Access Compliance Report

Public Rights-of-Way

(Pedestrian Signals)

Intersection ID: N/A	Main Street:	Cross Street: N/A	Location: N/A
ADA ID: AD8E937699B6	Signal Type: Two Push Buttons-Non APS	Overall Compliance: No	Severity Score: BTN 1:N/A BTN 2: N/A No BTN: N/A
Codes/Mitigation Info/Possible Solution		Field Measurements/Component Compliance

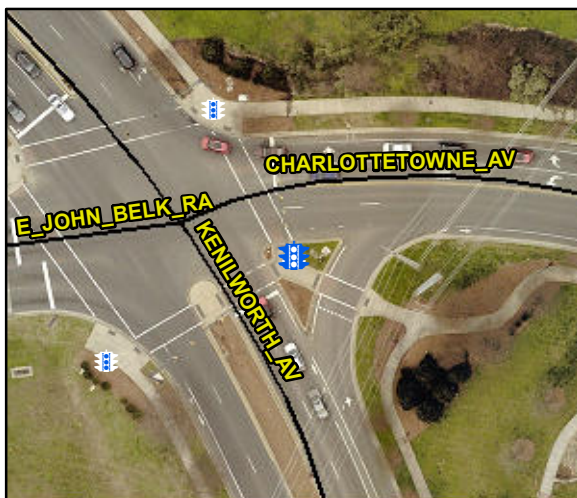
Possible Solutions: Replace Signal Push Button With APS Button on New Post. Remove & Relocate Sign.

PROW/ADA: TMUTCD 4e.08, R406.2, R404.7.3
